Work Order ID 158848

Item ID: 647.4116 Accept ***N900040100*** Setup Start ***NS1***
Revision ID: Stop ***NS2***
Item Name: Shim
Start Date: 4/3/2017 Start Qty: 12.00 ***12*** Cust Item ID:
Required Date: 5/12/2017 Req'd Qty: 12.00 ***12*** Customer:
Reference: SCHEDULED

ENGINEERING CHANGE NOTICE NL 04510

DWG NO. 647.4100

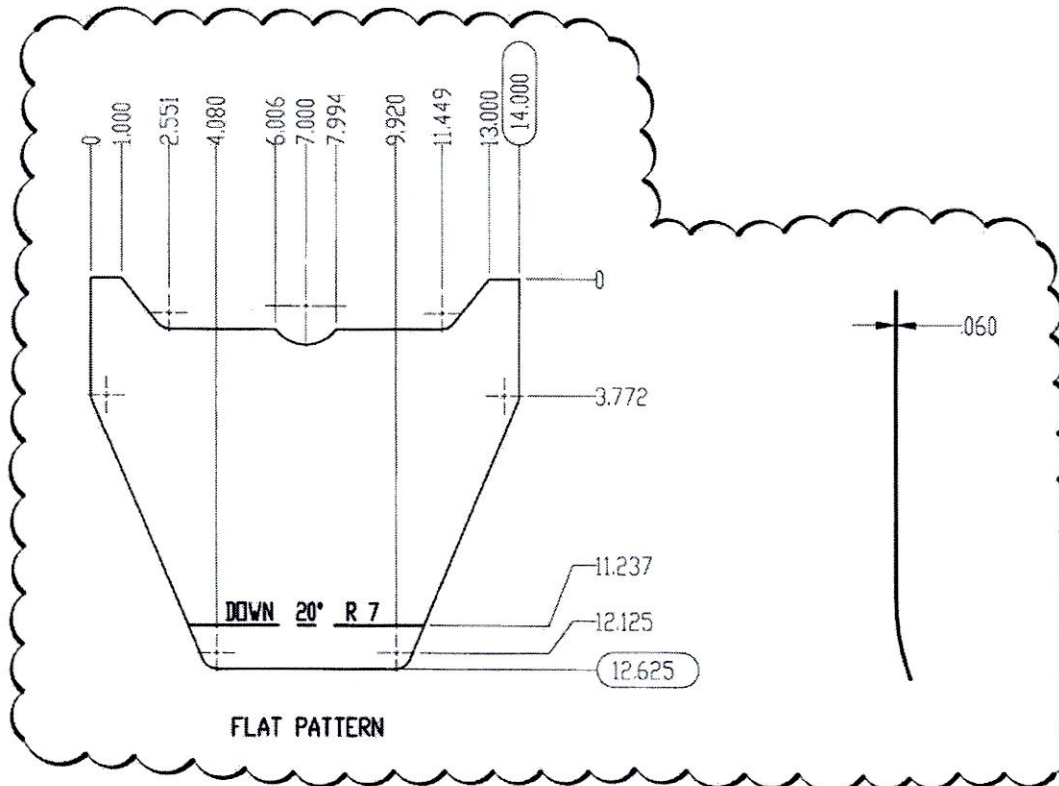
REASON: MODIFIED DOUBLER.

SHEET 1, ZONE C2 IS:

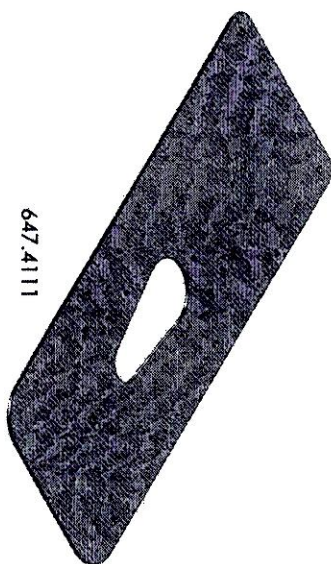
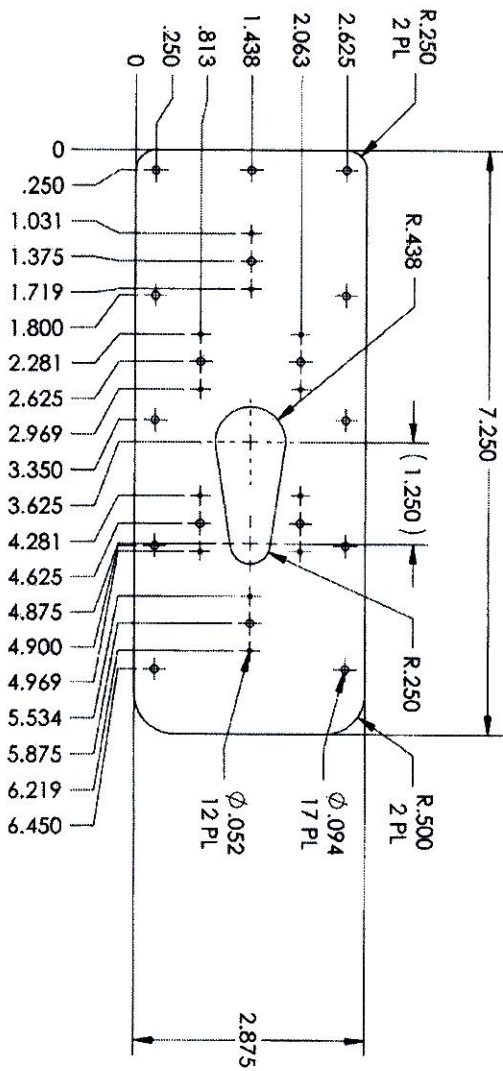
SHEET 1, ZONE A1 IS:

2. FINISH: HARD ANODIZE IAW MIL-A-8625 TYPE II,
 CLASS 2, COLOR BLACK;
 PRETREAT PR-148 ADHESION PROMOTER
 PRIME IAW MIL-P-23377J TYPE I CLASS N

IS
